■ CAB MOUNTING

155BO06

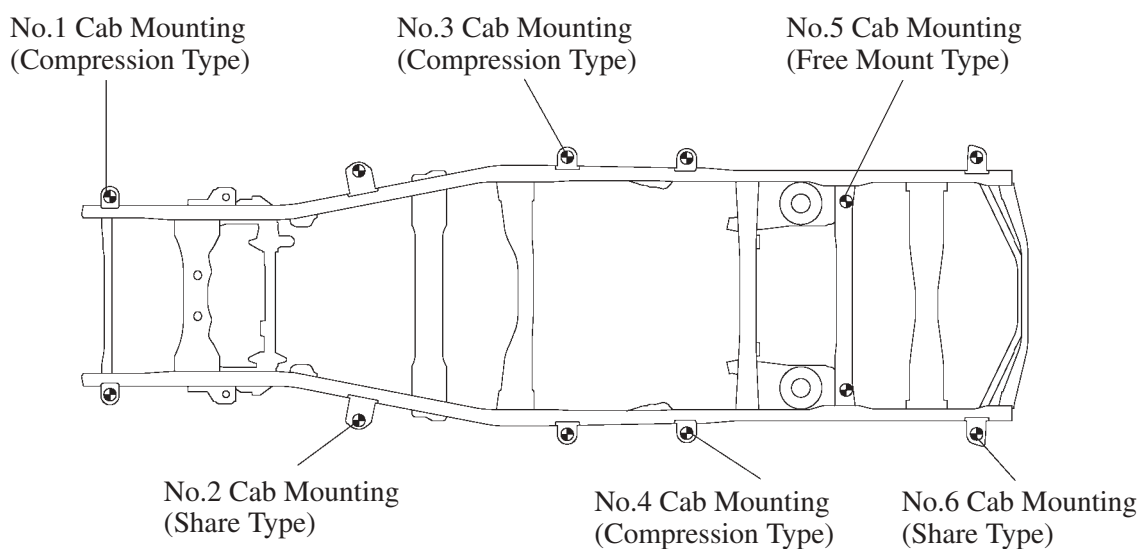
- The allocation of the cab mounts have been revised and the characteristics of the rubber cushion of the cab mounts have been optimized. Accordingly, the vehicle's riding comfort has been improved and noise and vibration have been reduced.
- The No.1 mount has been changed from the share-type to the compression type. The No.2 mount has been changed from the compression type to the share type. The remaining cab mounts use the same mounts as those of the previous model.
